Palo Verde Nuclear
Generating Station

**Subject: Palo Verde Nuclear Generating Station (PVNGS)
Docket Nos. STN 50-528, 50-529 and 50-530
License Nos. NPF-41, NPF-51 and NPF-74
Additional Information Regarding Relaxation Request
to NRC Order EA-03-009**

Revised Request for Relaxation of Order Requirements

Figure 1

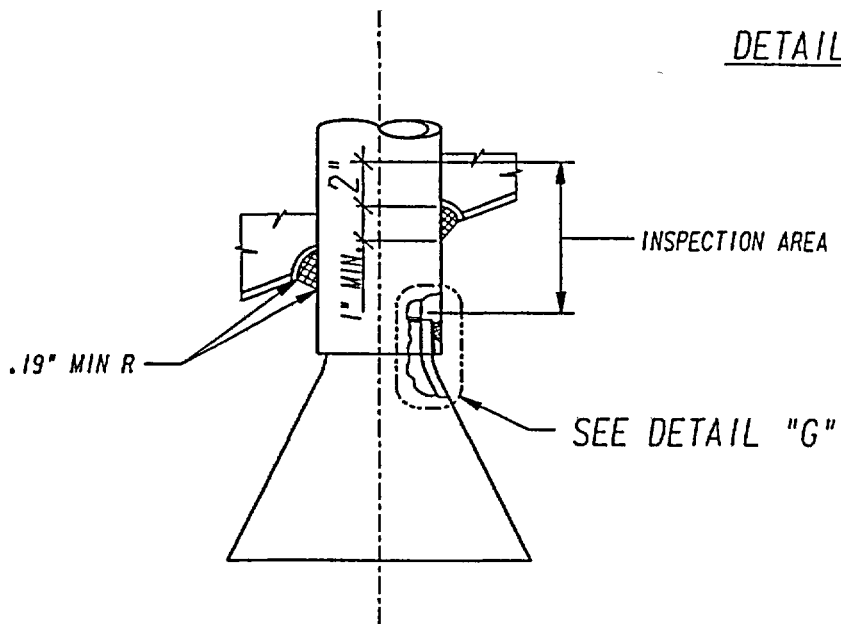
Due to the design of the funnel attachment to the CEDM nozzles (i.e., threaded connection with plug weld, see Figure 1), APS is unable to fully comply with the requirement to perform UT to the bottom of the nozzle. APS is planning to comply with the requirement to perform UT to two (2) inches above the J-groove weld and is not seeking relaxation from this requirement.

Experience gained from the previous two UT examinations of the CEDM nozzles completed at PVNGS (Unit 2 Refueling Outage 10 and Unit 1 Refueling Outage 10 in the spring and fall of 2002, respectively) has shown that scanning becomes impractical and ineffective from approximately 0.6 inches above the top of the nozzle's chamfer face to the bottom of the nozzle (see Figure 1, Detail G). Ultrasonic scans in this area do not yield useful data because of the geometry of the nozzle and funnel and the multiple signals reflected back by the threaded surfaces.

Ultrasonic testing (UT) of each RPV head CEDM penetration nozzle (i.e., nozzle base material) from 2 inches above the J-groove weld to approximately 0.6 inches above the top of the nozzle's chamfer face.

APS proposes a UT examination of each RPV head CEDM penetration nozzle (i.e., nozzle base material) to approximately 0.6 inches above the top of the nozzle's chamfer face. This inspection technique is consistent with the inspections performed in response to NRC Bulletins 2001-01, 2002-01, and 2002-02. The CEDM nozzle inspection includes multiple inspections from the nozzle inner surface. The primary inspection, which was demonstrated through the MRP/EPRI protocol, uses a dual element ultrasonic tip diffraction technique. The examination inspects from 2" above the J-groove weld to the lowest possible point on the nozzle. The probe design has a transmitter and receiver that are in close proximity to each other. In order to operate, both crystals must be in contact with the inner surface. Inherently, there is approximately 0.6" above the nozzle to funnel threaded joint interface that can not be inspected due to the configuration of the equipment (see Figure 1). In addition to the requirement of NRC Order Section IV.C(1)(b)(i) and IV.C(2)(b)(i), eddy current (ET) examination of the inside diameter (ID) of the CEDM nozzle is also performed as part of the PVNGS CEDM inspection program. This technique is capable of detecting ID initiated flaws. This technique operates beyond the range of the UT examination almost down to the chamfered edge between the nozzle and funnel (approximately 0.06" above the chamfer). This technique was also demonstrated through the MRP/EPRI protocol.

Figure 2

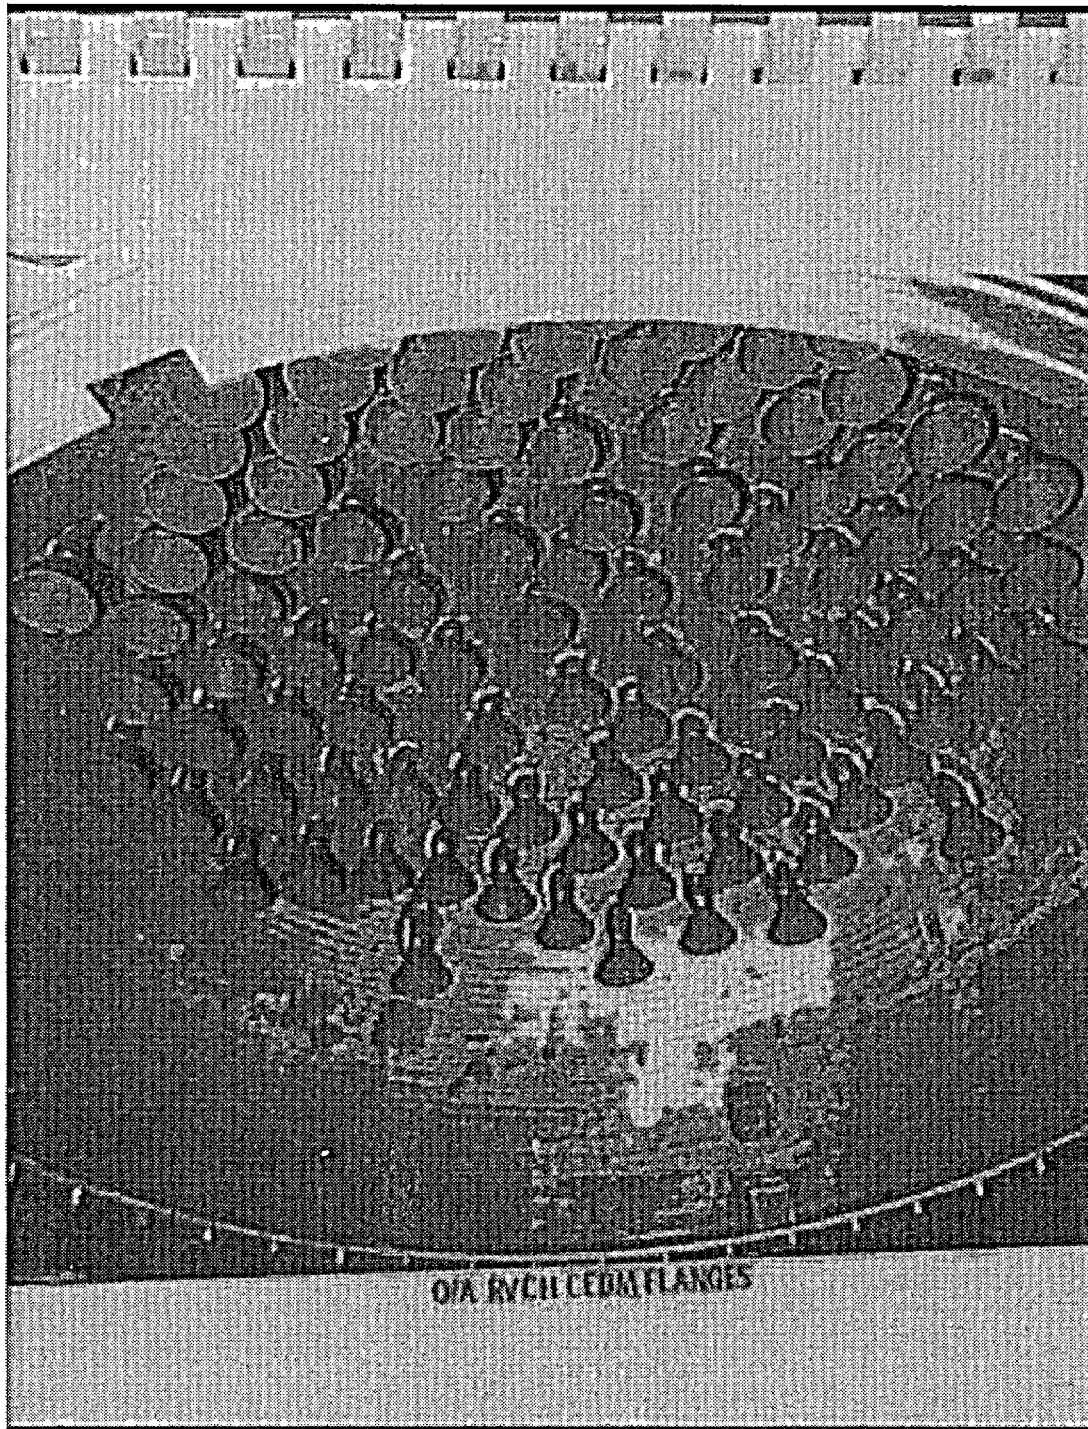
Order inspection options IV.C(1)(b)(ii) and IV.C(2)(b)(ii) require ET or PT of the wetted surface of each J-groove weld and RPV head penetration nozzle base material at least two (2) inches above the J-groove weld. Due to the location and proximity of the funnels to each other (see Figure 2), APS is unable to fully comply with the requirement to perform ET or PT of the wetted surfaces near the bottom of the nozzle. In order for APS to comply with this requirement, APS would need to develop new remote tooling or remove and reinstall a large number of funnels. Personnel radiation exposure for performing a manual PT would be excessive. The next outage is due to start on March 29, 2003, and there is not sufficient time for planning this inspection option. APS estimates the exposure for this examination method to be at least 30 times the dose of the proposed UT/ET examination discussed in Section V above. Therefore, it is not practical to perform ET or PT of the wetted surface of each J-groove weld.
